STAFF REPORT
COMMUNITY DEVELOPMENT DEPARTMENT

SUBJECT: H-2020-0015
Pine 43 No. 3

Final plat consisting of 112 buildable lots and 16 common lots on 12.45 acres of land in the R-15 zoning district for the third phase of Pine 43 Subdivision.

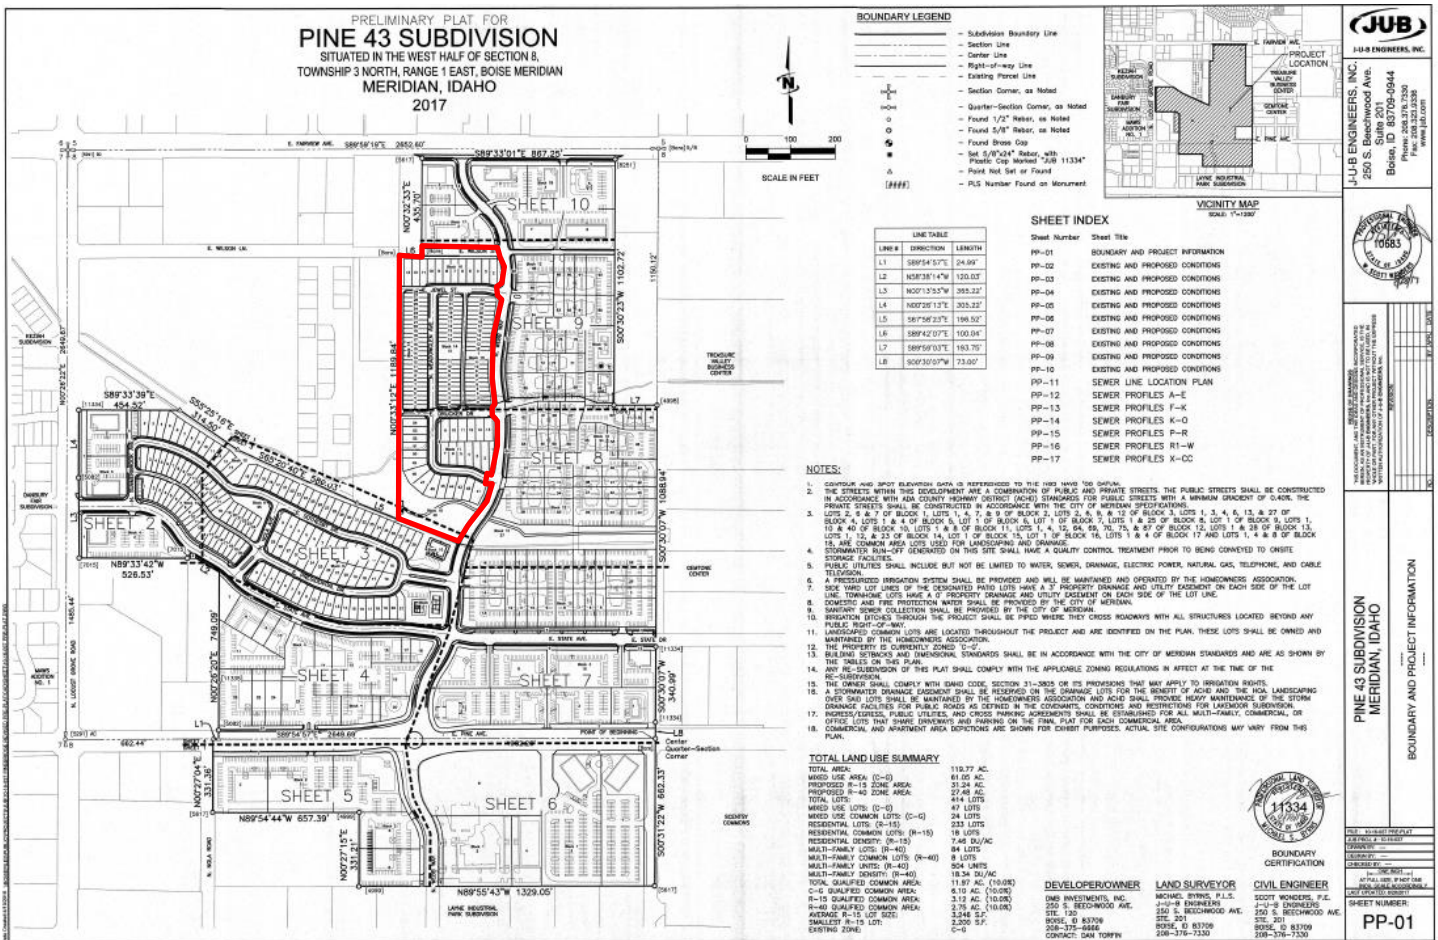
The number of lots for single-family detached homes decreased from 38 to 19 and the number of lots for townhomes increased from 68 to 93. Staff is amenable to this change.

PLAT SHOWING
Pine 43 Subdivision No. 3

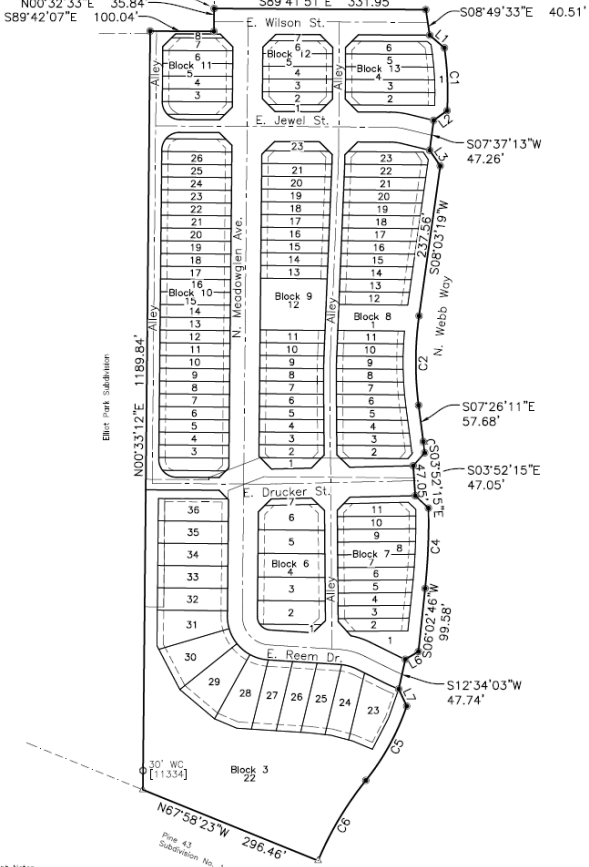
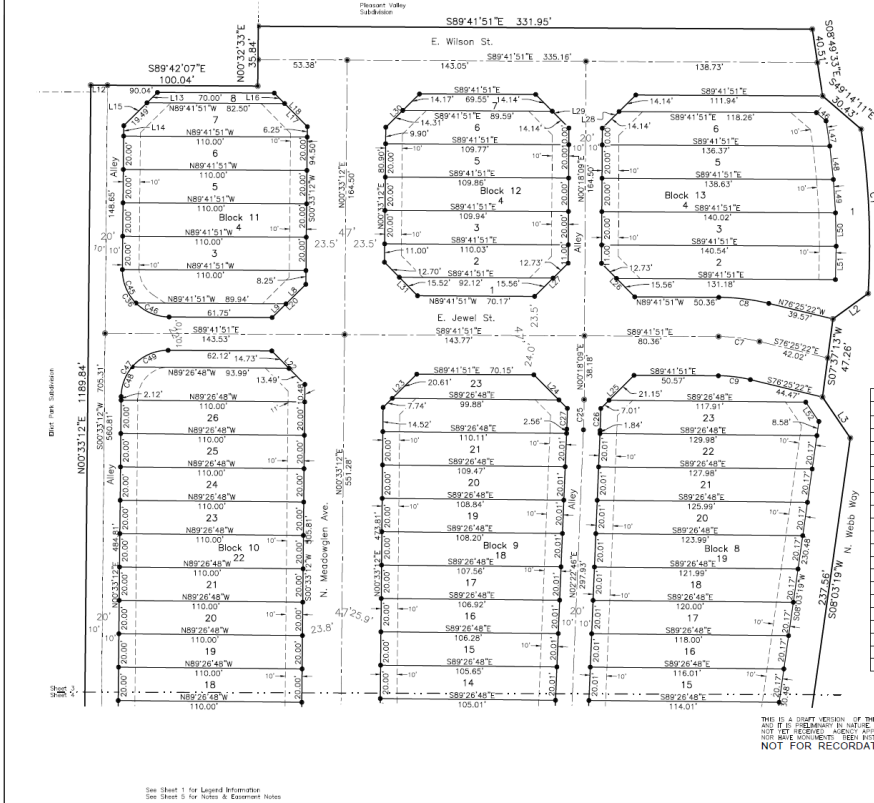
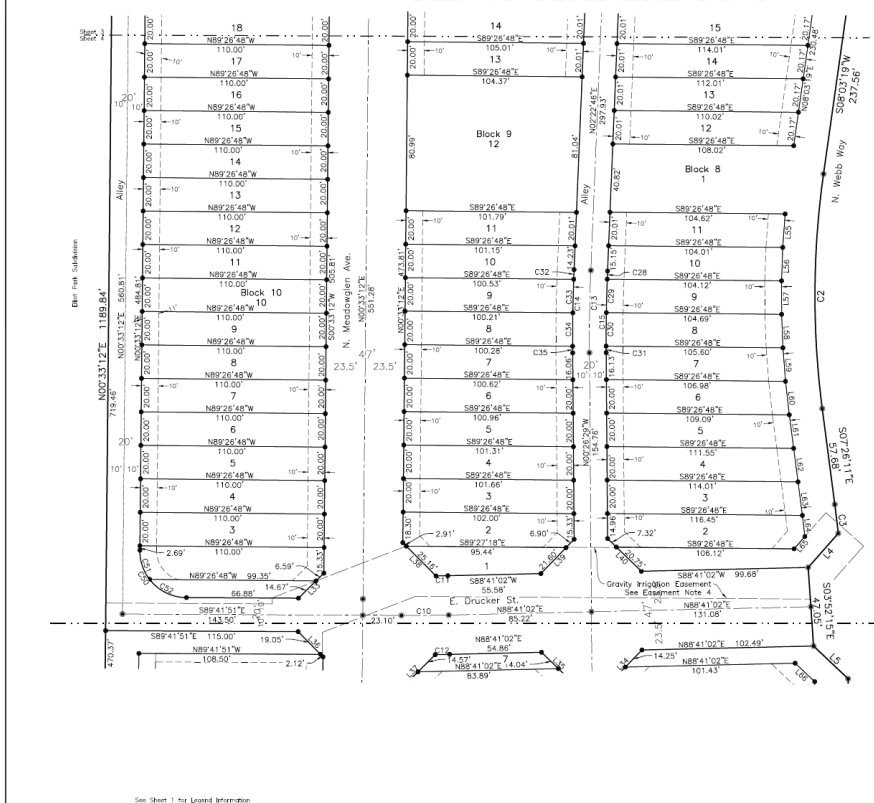
- a. Note #11: Include the recorded instrument number of the Development Agreement (#2018-000751).
- b. Note #12: Include the recorded instrument number of the ACHD License Agreement.

- c. Note #4: Include the recorded instrument number of the gravity irrigation easement.
- d. Note #5: Revise to read: "No Utility Easement shown or designated hereon shall preclude the construction and maintenance of hard-surfaced driveways or other similar hard surface flatwork, however permanent structures, trees, brush, or perennial shrubs or flowers within the area described for this easement shall be prohibited."

- e. Include the recorded instrument number for the Easements.

- f. Depict lot numbers on Lots 1 and 2, Block 11; Lots 1, 2, 27 and 28, Block 10; and Lot 22, Block 9.
- g. Extend E. Drucker Street and E. Jewel Street to the west property boundary so the alley that provides access to the lots in Block 16 complies with UDC 11-6C-3B.5e and is visible from a public street; or otherwise reconfigure this area to comply with UDC standards.
- h. An off-street parking area shall be provided for the alley accessed townhomes in Block 8 that front on W. Webb Way similar to that proposed in Blocks 6 and 10 on the preliminary plat.

A copy of the revised plat shall be submitted for City Engineer signature.

LANDSCAPE PLAN - AREA THREE

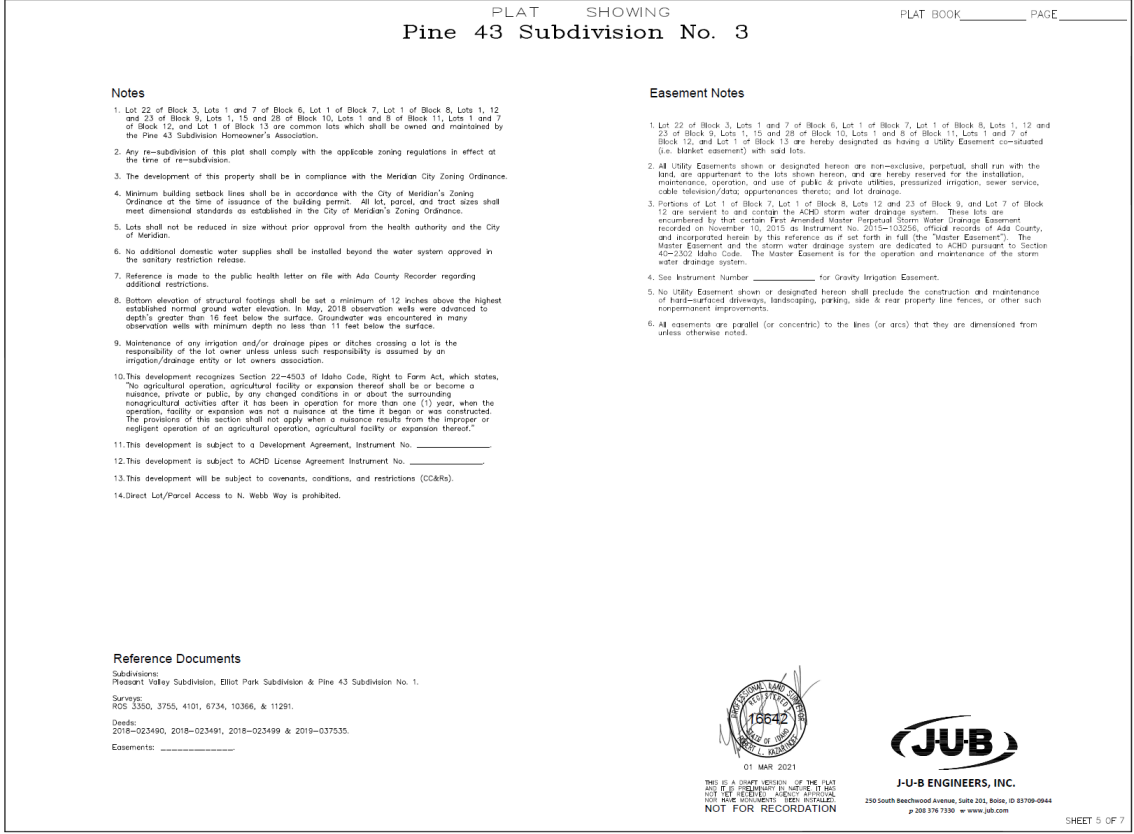
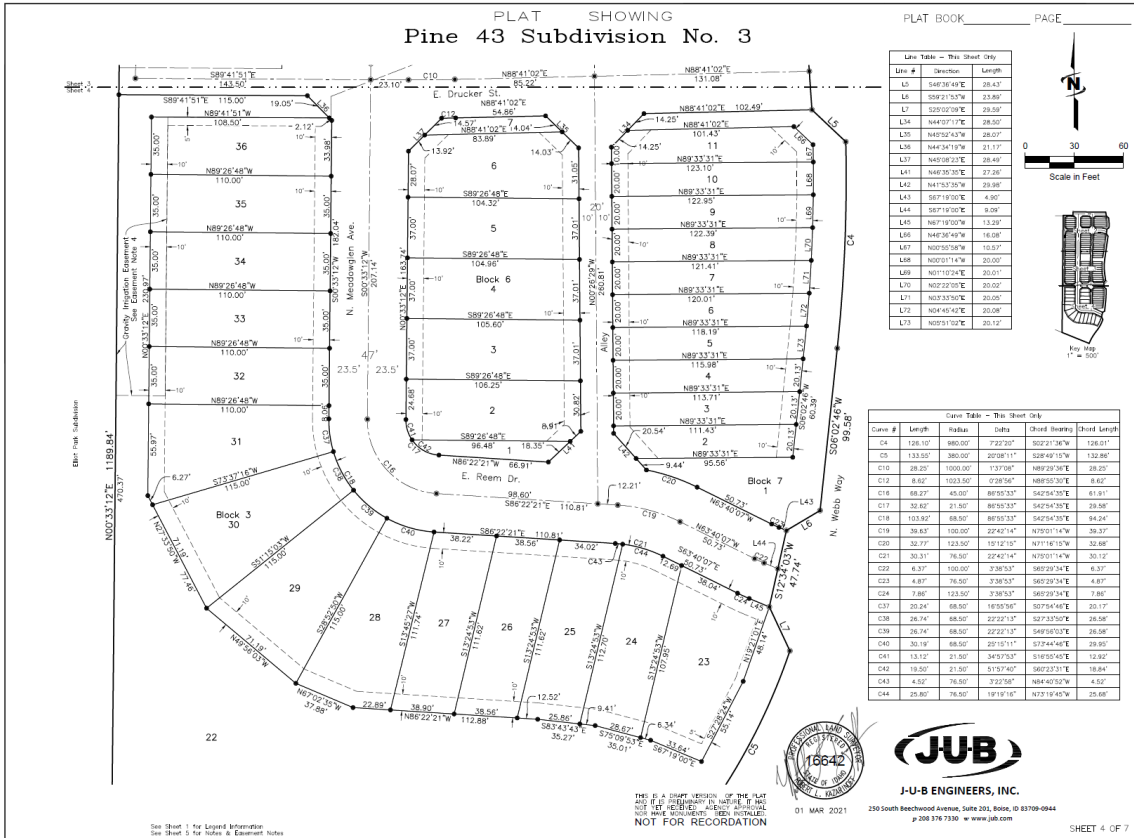
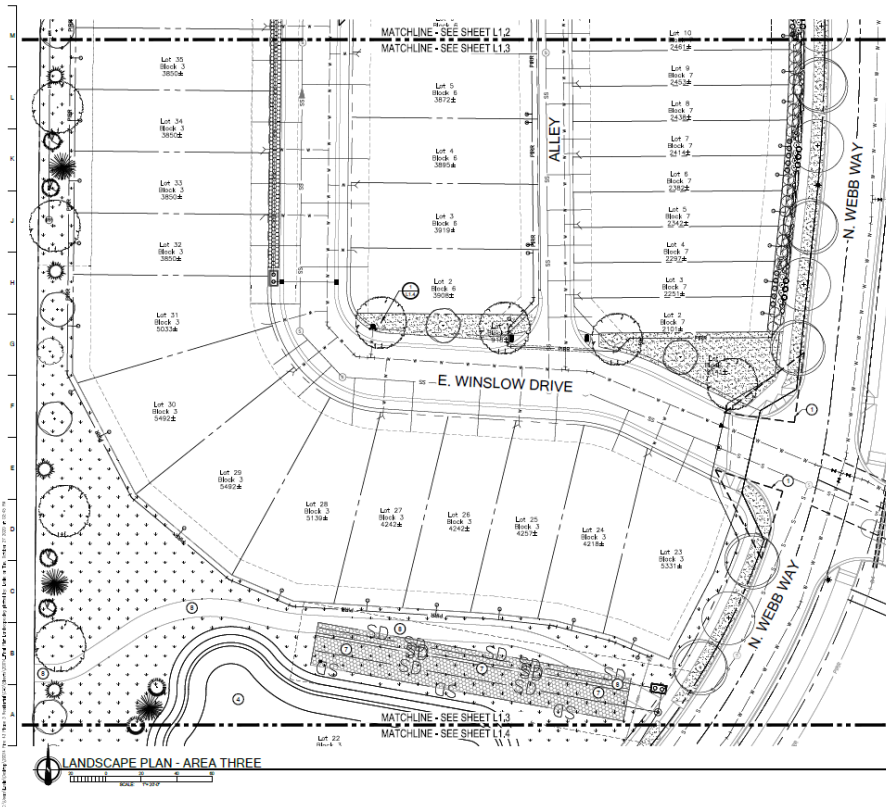
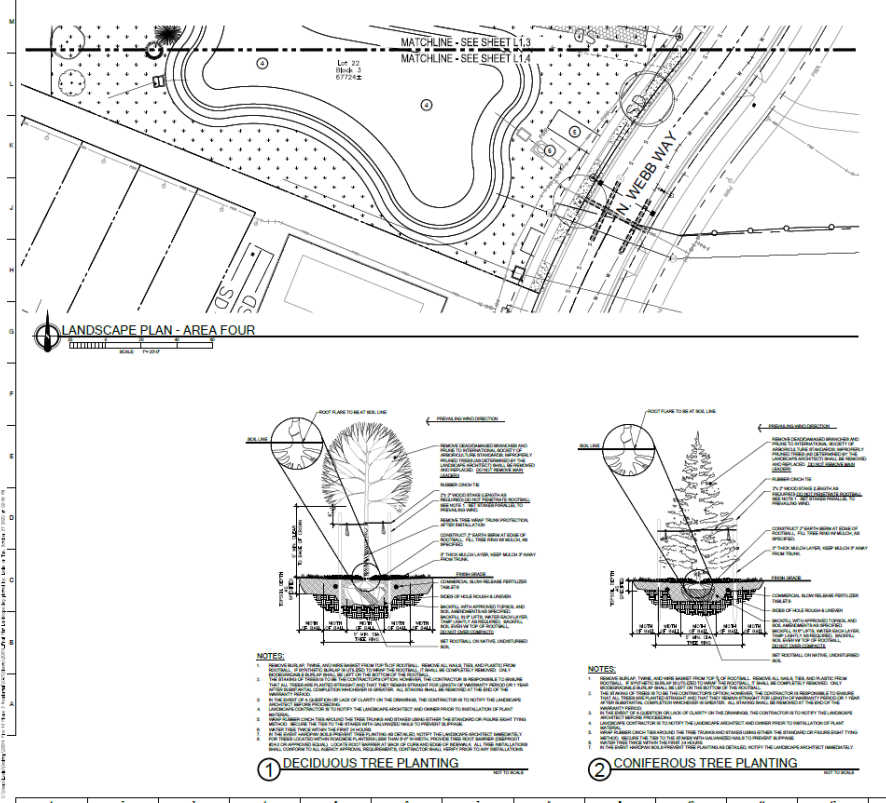
5. The landscape plan prepared by Rodney Evans + Partners, dated 10/27/2020, included in Section V.C, shall be revised as follows:
 - a. Depict landscaping on Lot 15, Block 10 in accord with the standards listed in UDC 11-3G-3E.

- b. Extend E. Drucker Street and E. Jewel Street to the west property boundary so the alley that provides access to the lots in Block 10 complies with UDC 11-6C-3B.5e and is visible from a public street; or otherwise reconfigure this area to comply with UDC standards.

- c. Depict attached sidewalks within Lot 1, Block 11 and Lot 28, Block 10 in accord with UDC 11-3A-17.
 - d. Depict an off-street parking area for the alley accessed townhomes in Block 8 that front on W. Webb Way similar to that proposed in Blocks 6 and 10 on the preliminary plat.

- e. Depict wrought iron fencing along the Jackson Drain to protect public safety *unless* the applicant can demonstrate to City Council's satisfaction that public safety can be preserved without the addition of a fence.

- f. Depict pedestrian lighting along the multi-use pathway within the common area adjacent to the Jackson Drain (i.e. Lot 22, Block 3); submit a detail for the lighting fixtures.
